RFP Addendum No. 01

DATE ISSUED: January 25, 2026
TO: Invited Bidders
FROM OWNER'S REPRESENTATIVE: Collin Frink
Plante Moran Realpoint
3000 Town Center, Suite 100
Southfield, MI 48075
ON BEHALF OF CLIENT: Livonia Public Schools (LPS)
SUBJECT: Addendum for LPS Pool Filtration – Franklin & Churchill High
Schools

ADDENDUM

Addendum No:	001
Project:	Livonia Public Schools FHS & CHS Filtration Projects Livonia, MI
Project No:	2025-042
Owner:	Livonia Public Schools
Documents Issued:	January 6, 2026
Addendum Issued:	January 23, 2026

1
AQ0.0
POOL REFERENCE PLAN
1/8" = 1'-0"

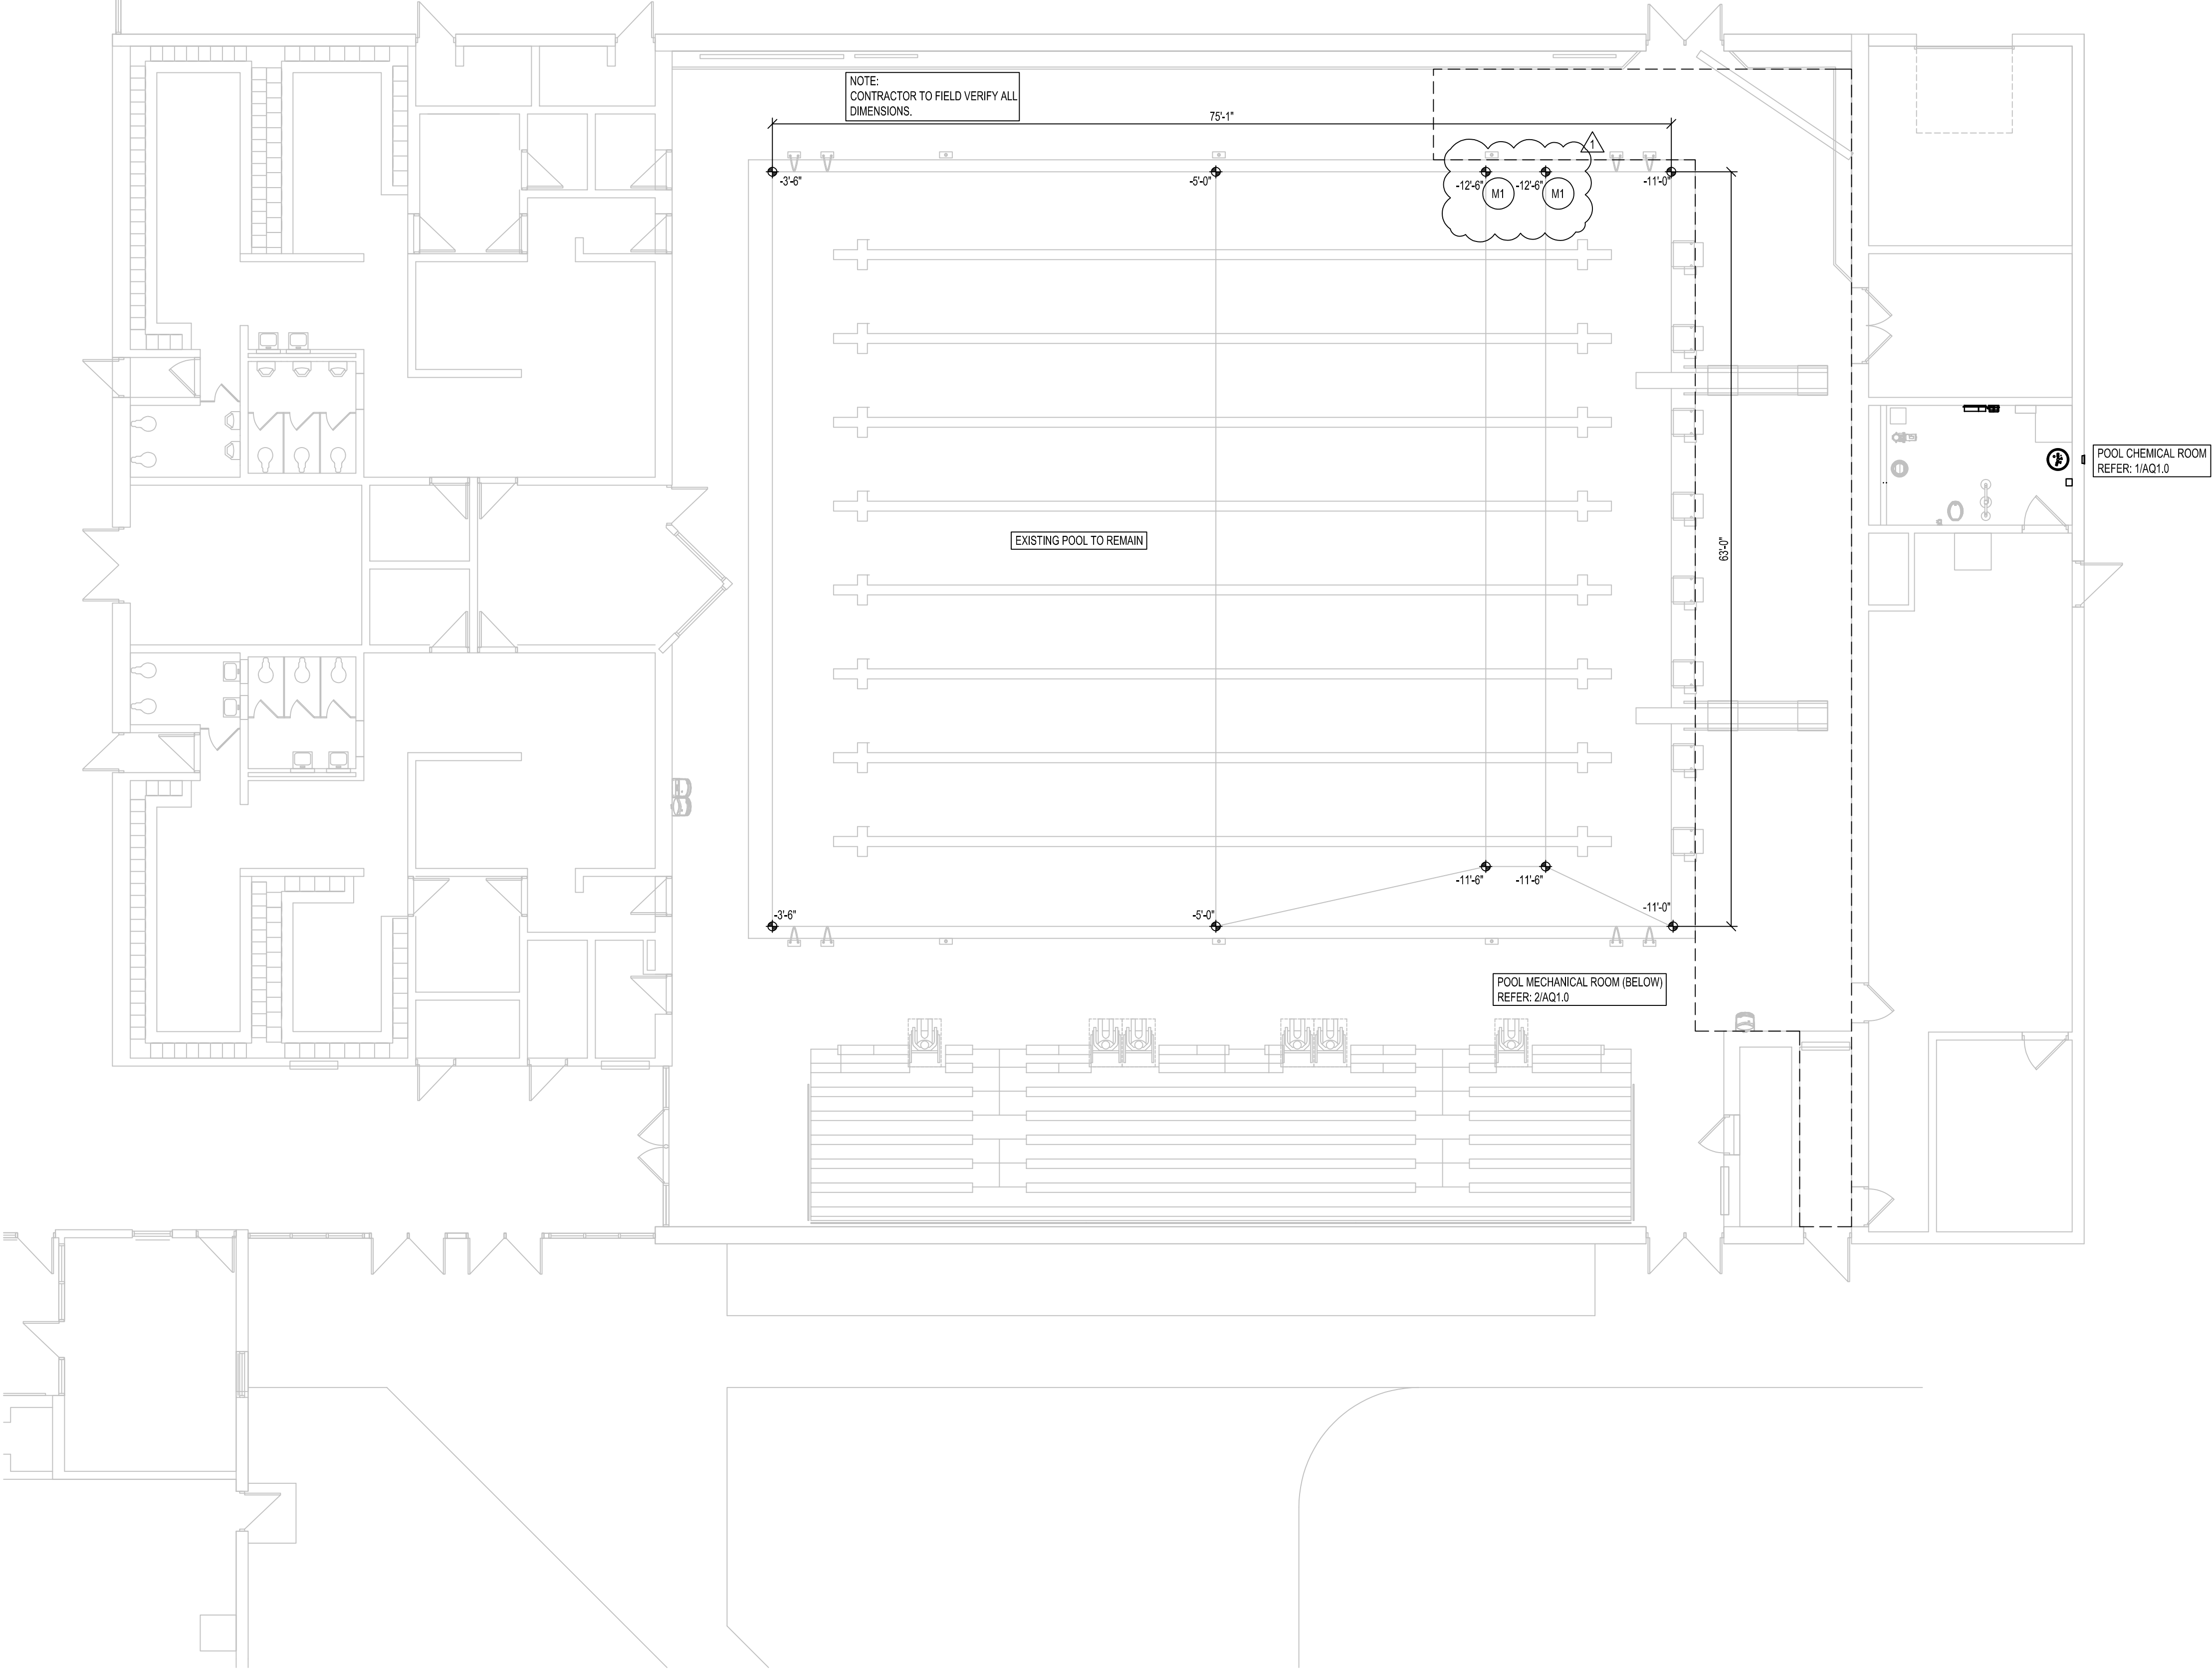
- 1. Refer to Sheet AQ0.0 – Pool Reference Plan (issued):**
 - a. Main Drain Schedule added to sheet.
 - b. Main Drain M1 tagged on plan.
- 2. Refer to Sheet AQ0.1 – Pool Demolition Plan (issued):**
 - a. Demolition note D10 added to plan and note block indicating removal of VGB covers.
- 3. Refer to Sheet AQ1.0 – Pool Renovation Plan (issued):**
 - b. Note added to plan indicating new main drain covers.

NOTE:
1. EXISTING MAIN DRAIN SUMPS TO REMAIN. NEW GRATES MUST BE MANUFACTURED BY NEPTUNE BENSON. DALDORADO, AQUASTAR, PADDOCK OR APPROVED EQUAL. THE MANUFACTURER INDICATED IS THE BASIS OF DESIGN. CONTRACTOR TO VERIFY MANUFACTURER OF EXISTING GRATE.
2. MAXIMUM FACE VELOCITY MUST NOT EXCEED 1.0 FOOT PER SECOND.
3. OPEN AREA IS BASED ON MANUFACTURER'S DATA.
4. THE INSTALLED LIFE OF THE MAIN DRAIN COVER MUST BE A MINIMUM OF 10 YEARS.
5. FASTEN MAIN DRAIN COVER TO SUMP WITH SIS TAMPER PROOF FASTENERS AT A SPACING NO GREATER THAN 24" O.C. REFER TO SUMP AND GRATE MANUFACTURER'S INSTALLATION INSTRUCTIONS.
